City of Houston Texas

REVIEWED FOR COMPLIANCE

FIRST FLOOR PLAN
 1/8" = 1'-0" (11x17)
 1/4" = 1'-0" (22x34)

FLOOR PLANS

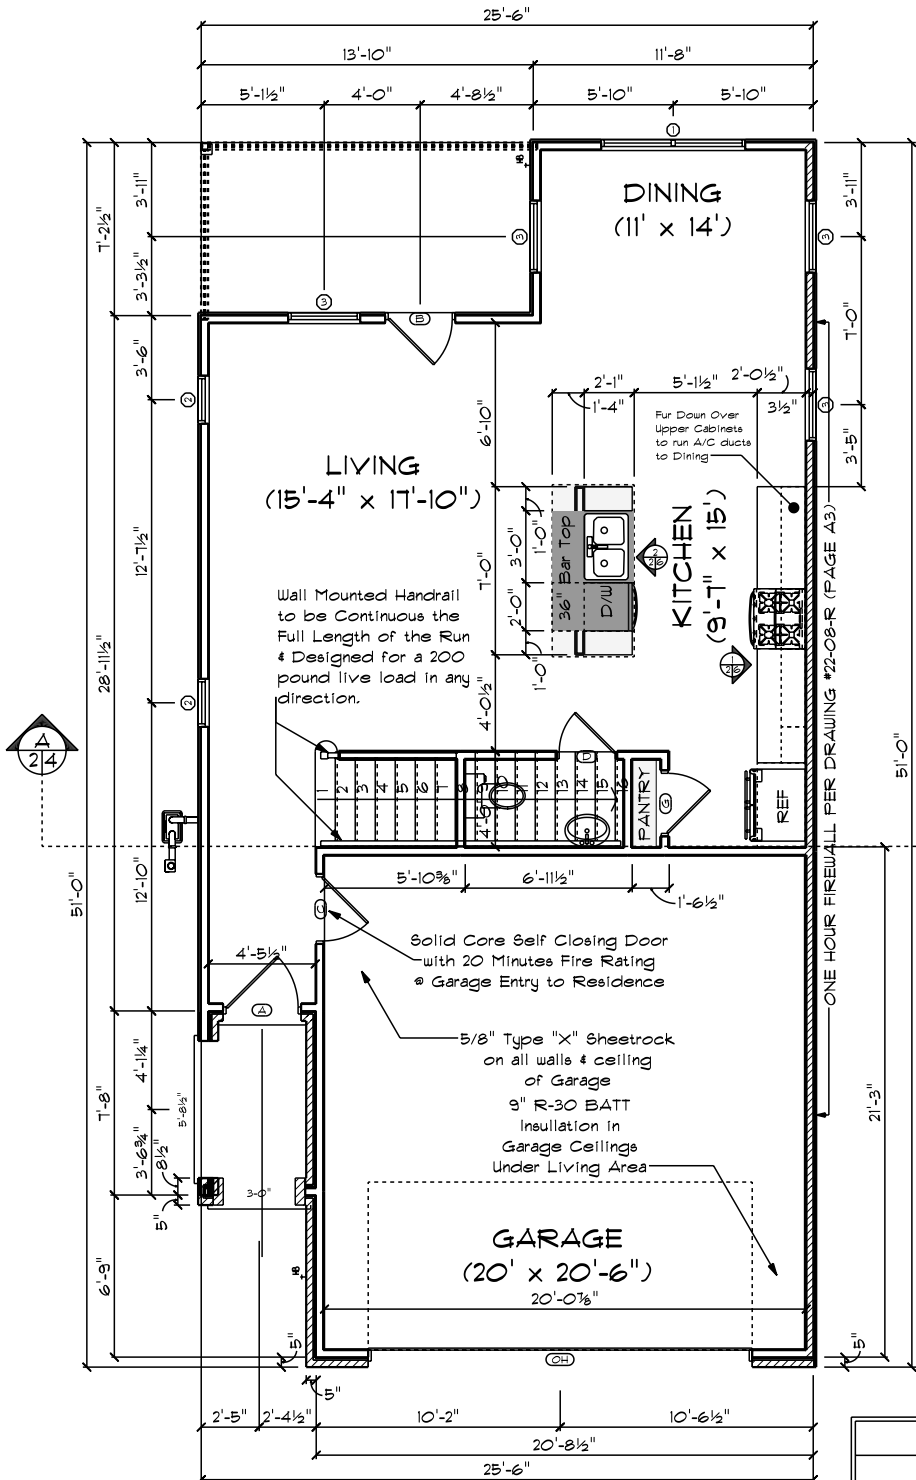
Windows (Sill Height) R312.2.1
 In dwelling units where the opening of an operable window is located more than 12 inches above the finished grade or surface below, the lowest part of the clear opening of the window shall be a minimum of 24 inches above the finished floor of the room in which the window is located. Glazing between the floor and 24 inches shall be fixed or have openings through which a 4 inch diameter sphere cannot pass.

SECOND FLOOR PLAN
 1/8" = 1'-0" (11x17)
 1/4" = 1'-0" (22x34)

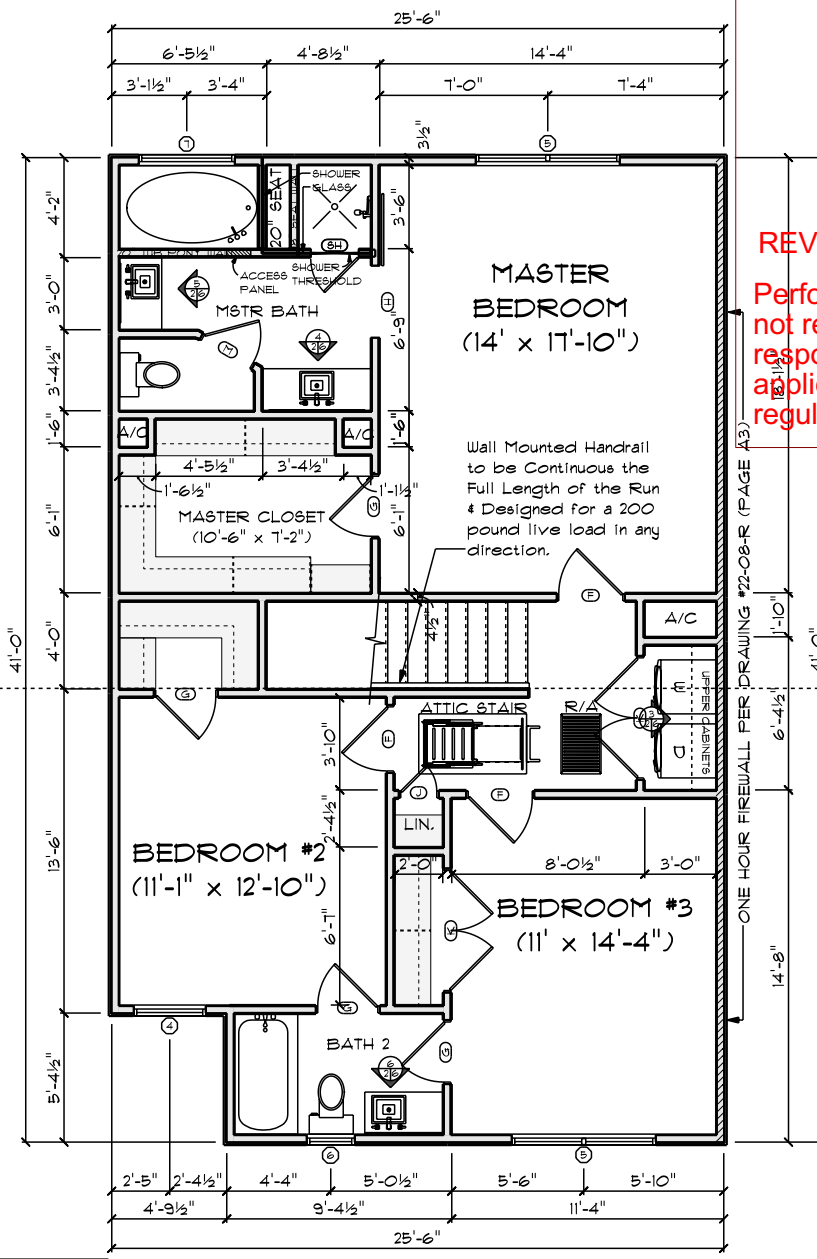
ACCESS STAIRWAY SHALL COMPLY WITH SECTION M1305.1.3 AS AMENDED BY HOUSTON. THE REQUIREMENTS HAVE BEEN REVISED AS SUCH. CONTAINING APPLIANCES REQUIRING ACCESS SHALL BE PROVIDED WITH AIRWAY WITH A CLEAR OPENING NOT LESS THAN 22-INCHES IN WIDTH HARDWARE, AND A LOAD CAPACITY OF NOT LESS THAN 350-POUNDS. AN ACCESS PASSAGEWAY LARGE ENOUGH TO ALLOW THE LARGEST APPLIANCE, BUT NOT LESS THAN 30-INCHES HIGH AND 30-INCHES NOT MORE THAN 20-FEET IN LENGTH WHEN MEASURED ALONG THE CENTERLINE PASSAGEWAY FROM THE OPENING TO THE APPLIANCE. PASSAGEWAY SHALL HAVE CONTINUOUS SOLID FLOORING IN ACCORDANCE WITH IBC 505.2.1.1; NOT LESS THAN 24-INCHES WIDE. A LEVEL SERVICE SPACE AT LEAST 30-INCHES DEEP AND 30-INCHES WIDE SHALL BE PRESENT ALONG ALL SIDES OF THE APPLIANCE WHERE ACCESS IS REQUIRED. THE CLEAR ACCESS OPENING DIMENSIONS SHALL BE A MINIMUM OF 30-INCHES BY 54-INCHES WHERE SUCH DIMENSIONS ARE LARGE ENOUGH TO ALLOW REMOVAL OF THE LARGEST APPLIANCE.
